# Design Review Board

| 5:40 - 6:40 | 1) <a href="#">Recommendation Meeting: CSO 24</a> | Omar Akkari |

Recommendation Meeting Design Review Submittal  
CSO 24  
Spokane, Washington  
June 28, 2017

D D - D': BRICK STAIR SECTION

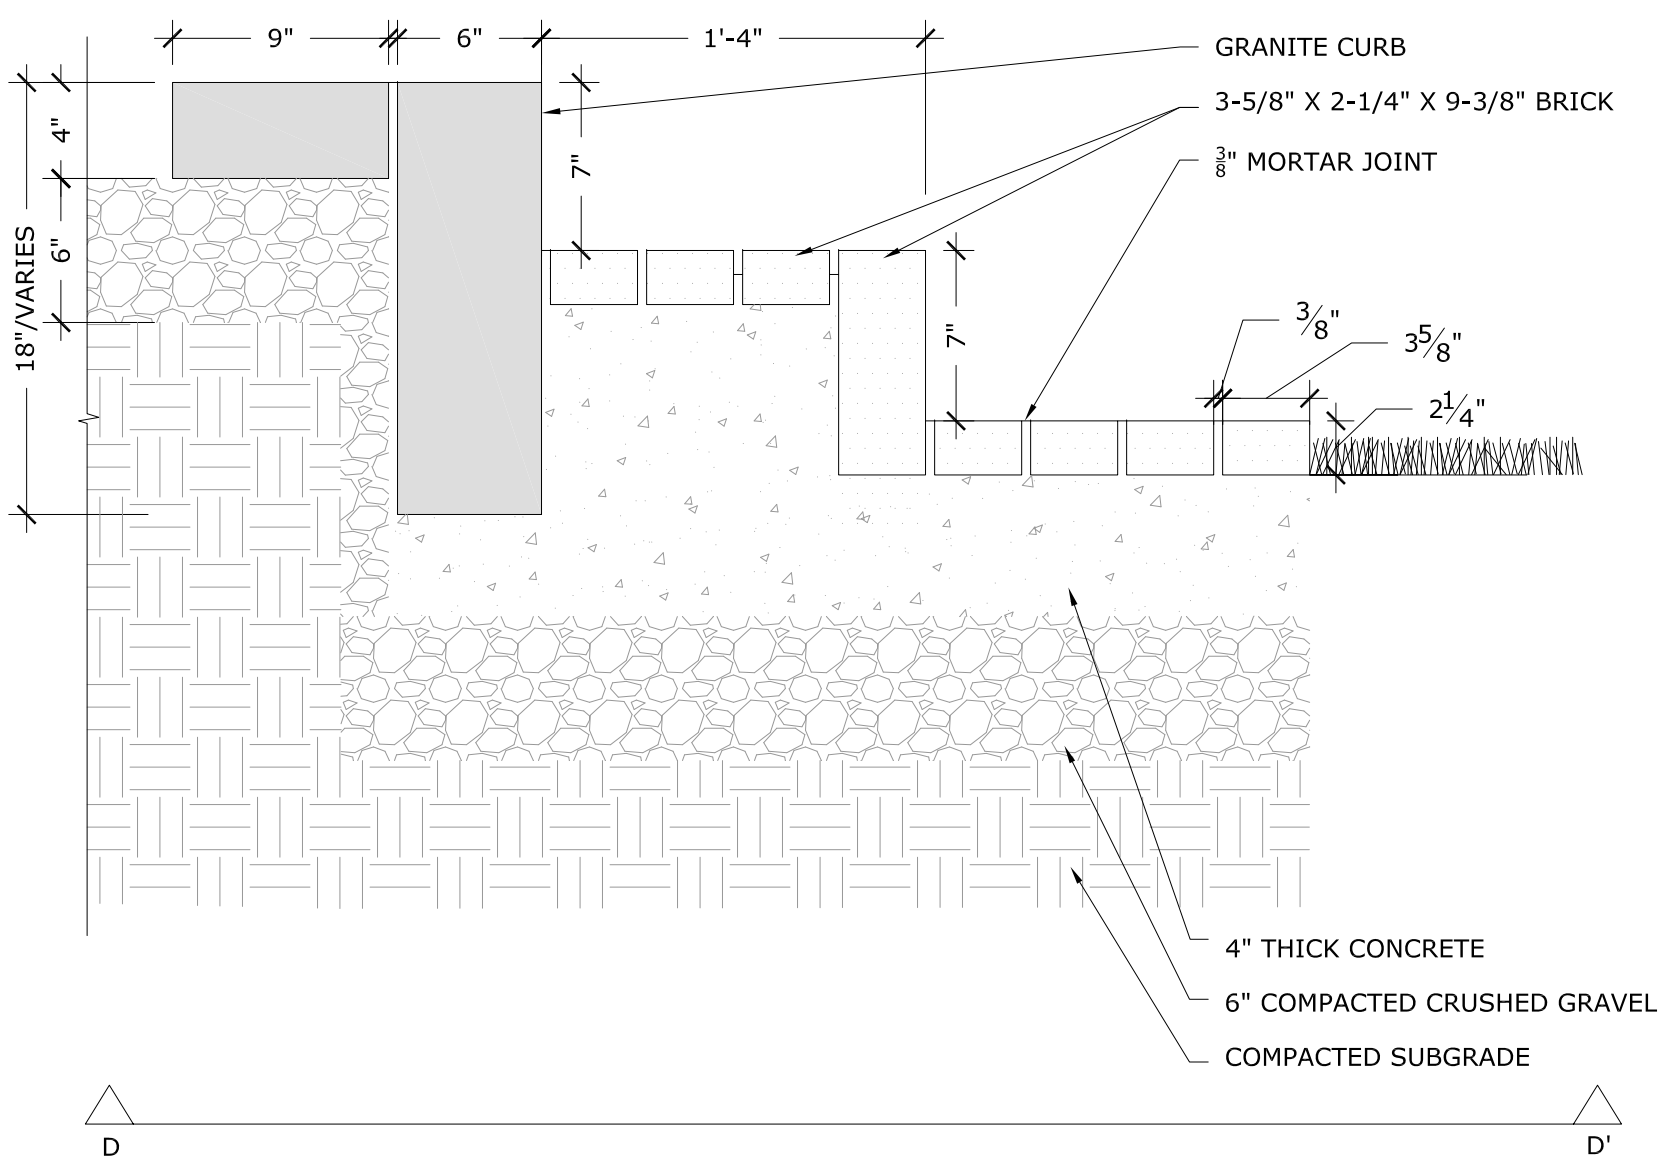
- 1 STREET SIDEWALK
- 2 CSO ACCESS STAIRS
- 3 BRICK STAIRS/ELEVATION CHANGE. SEE SHEET L-8 DETAIL D.
- 4 GRANITE CURB
- 5 OPEN USE AND AMPHITHEATER
- 6 INTAKE AIR VENT AS SEAT WALL
- 7 RPBP LOCATION
- 8 OVERHEAD STRUCTURE WITH ELECTRICAL FOR EVENTS
- 9 6" CONCRETE MOWCURB. SEE SHEET L-9 DETAIL B.
- 10 BRICK PLANTER WITH OVERHEAD STRUCTURE/ART INSTALLATION.
- 11 GARBAGE CAN. MAGLIN MCWR1400-32-PCB-FB.
- 12 KIOSK AND CSO ELEC-METER.
- 13 PROPOSED BIKE RACK LOCATION .
- 14 TREE GRATES/POSSIBLE ART INCORPORATION.
- 15 WHITE CONCRETE BANDS.
- 16 18" CONCRETE SEATWALL. SEE SHEET L-8, DETAIL F.

C POURED IN PLACE CONCRETE  
SCALE = NTS

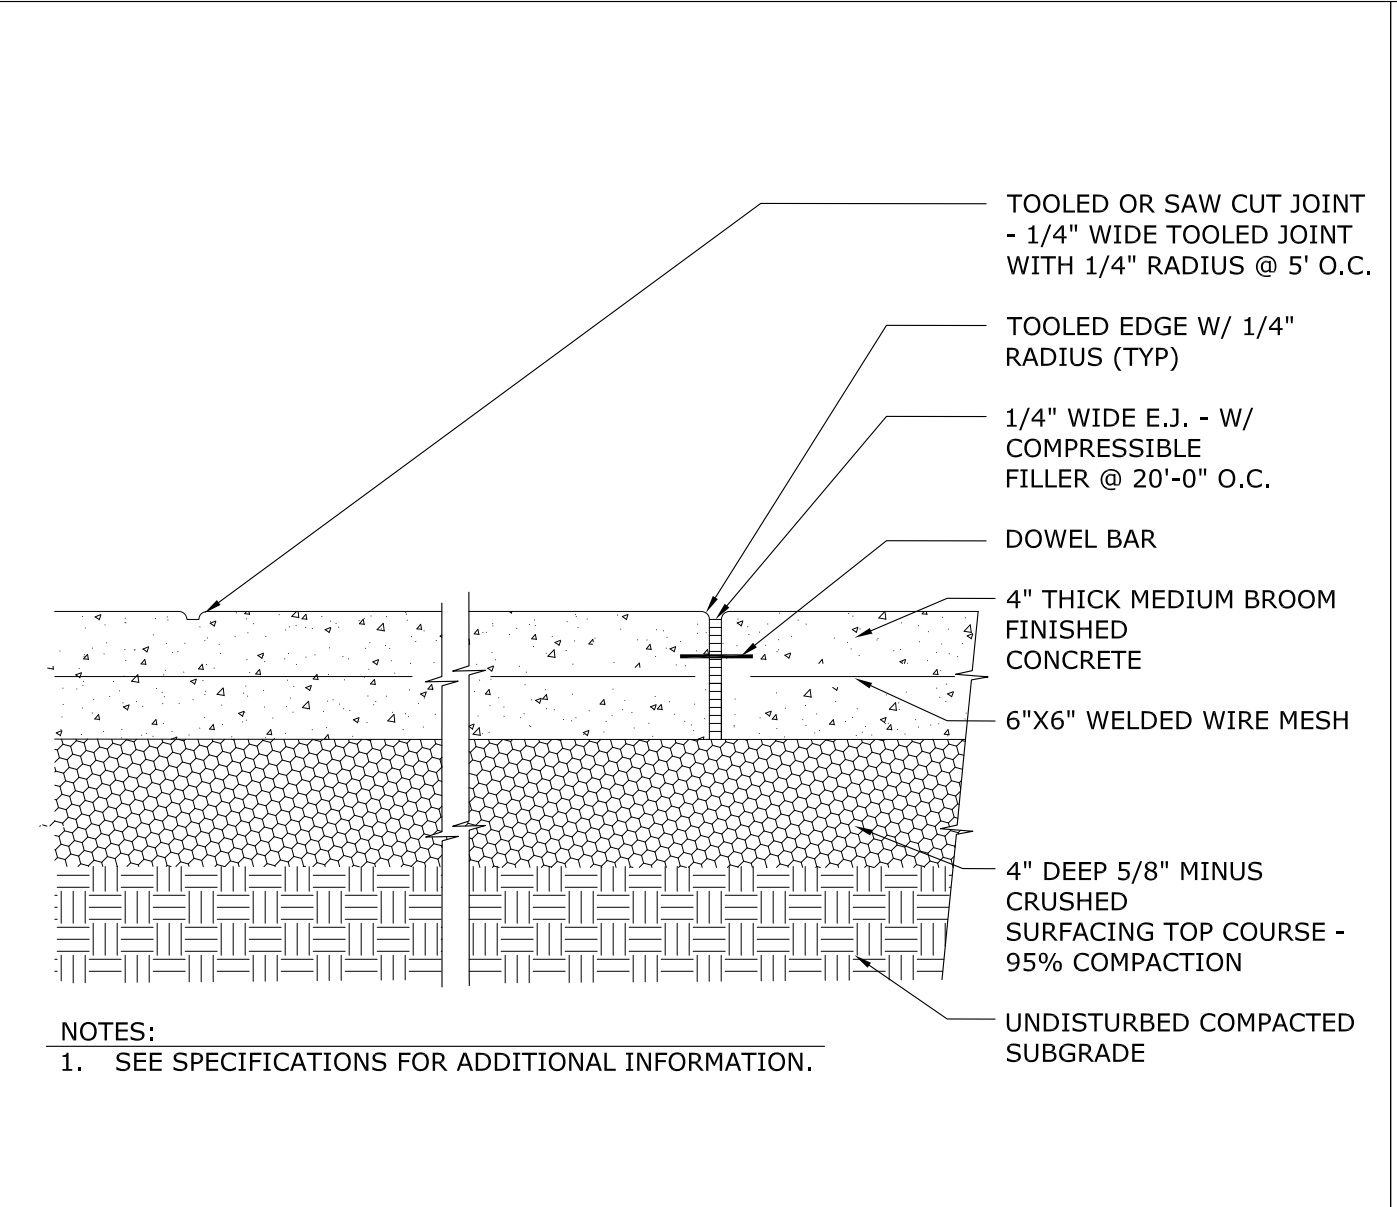
4. Are the "white concrete bands" a different in color from the concrete used in other areas of the plaza? The poured in place concrete detail (L-9 Detail C) does not indicate any differences. Please describe all concrete colors and surface treatments being used.

The white concrete bands are currently designed to be light, natural concrete. The field is to be an integral color concrete that is still under discussion. We will provide a full palette of colors and materials at the recommendation meeting.
